**RE: Addendum to the Contract Documents for the Argo Dam and Geddes Dam Coating and
Miscellaneous Repairs
Bid No. ITB-4261**

**ADDENDUM NO. 1
TO
BID DOCUMENTS
FOR
ARGO DAM AND GEDDES DAM
COATING AND MISCELLANEOUS REPAIRS
FOR THE
CITY OF ANN ARBOR, MICHIGAN**

Title
 ARGO DAM
 SITE WORK

Drawing No. 1C-102

SECTION C1
SCALE: 1" = 10'

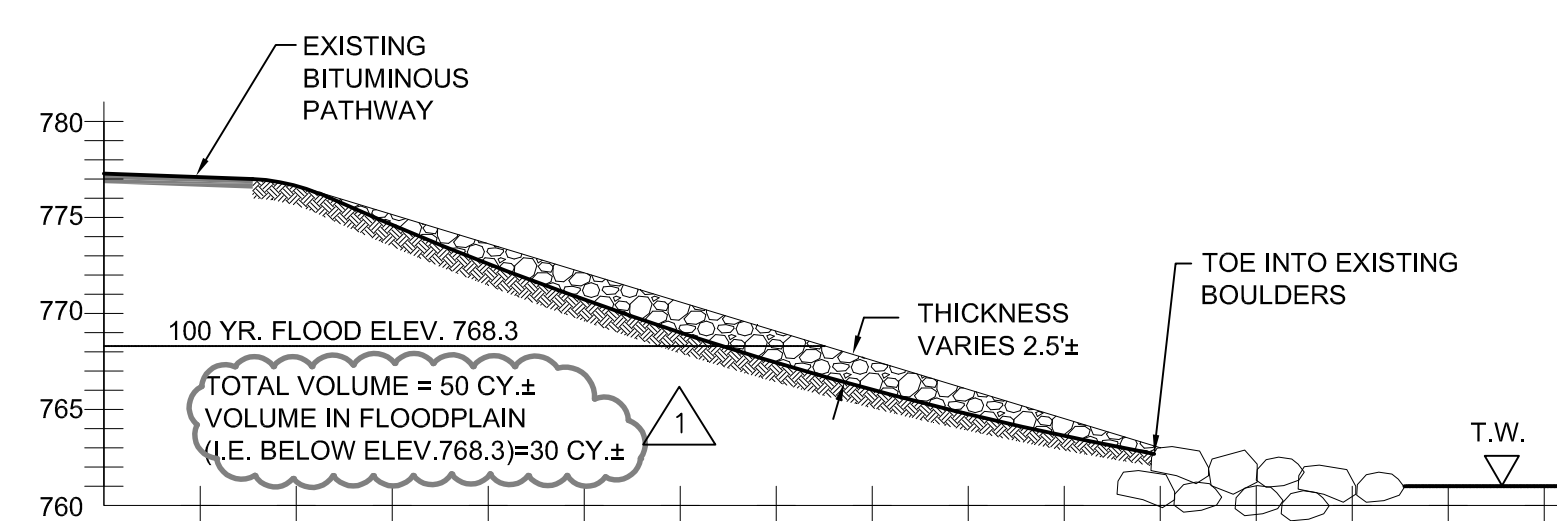
- Q:** Drawing 1C-102 Section C1 indicates 110 CY of rip rap at the Argo site, while the plan view on this page and the bid form show 50 CY. Which is correct?
- A:** **The correct quantity is 50 CY.**
